Interpretation

Rule 215C4b **Grounding of circuits, supporting structures, and equipment --
Non-current-carrying parts -- Use of insulators in anchor guys**
(2012 Edition, pages 75-76)
(2 October 2012) IR569

Figure 9
Span Guys Parallel with
Subtransmission, Distribution Pri, Sec, & Communications

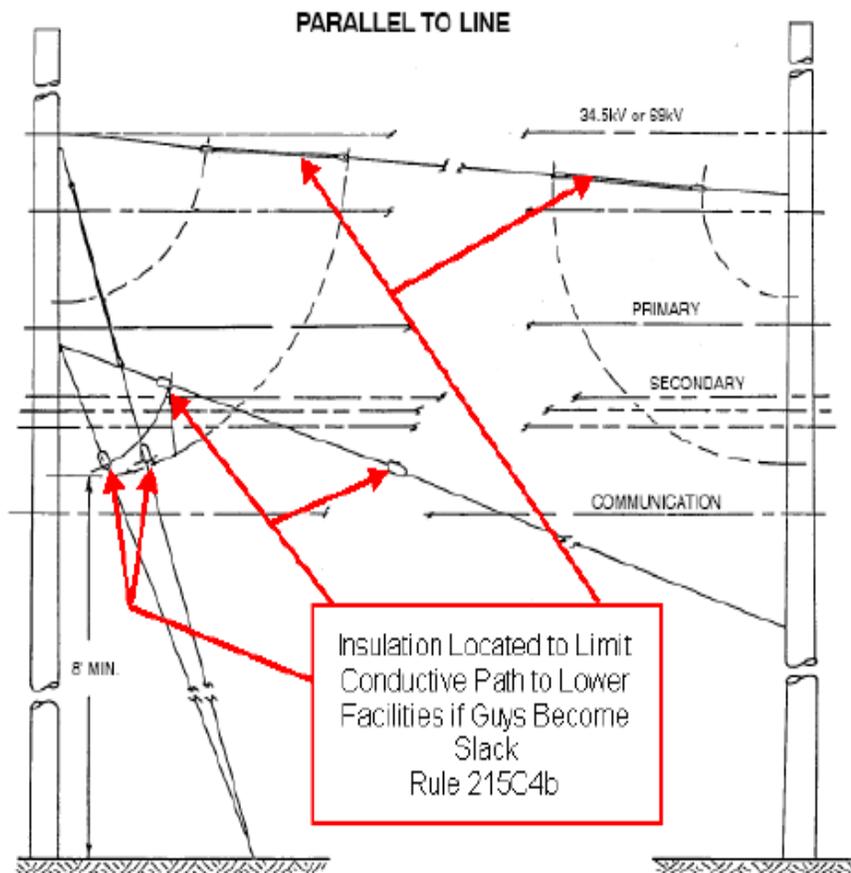
It is the belief (interpretation) that the Figure 9 guy insulator placement configuration attached represents the intent of NESC Rule 215C4b and 215C4c. In this example, sagging guys can present a safety (and reliability) hazard if the guy insulators are not located properly.

Rule 215C4b does not apply to specific design configurations, but applies to any design configuration. The intent of this Rule is to limit the likelihood of voltage transfer between facilities due to a slack or broken anchor guy. Even though the Rule only uses the word slack to describe how voltage could be transferred, it also applies to broken guys since a broken guy is the ultimate in being slack. Note that the Rule is a performance rule, not specific to configuration (dead-end, perpendicular, parallel, etc.) or to clearance requirements.
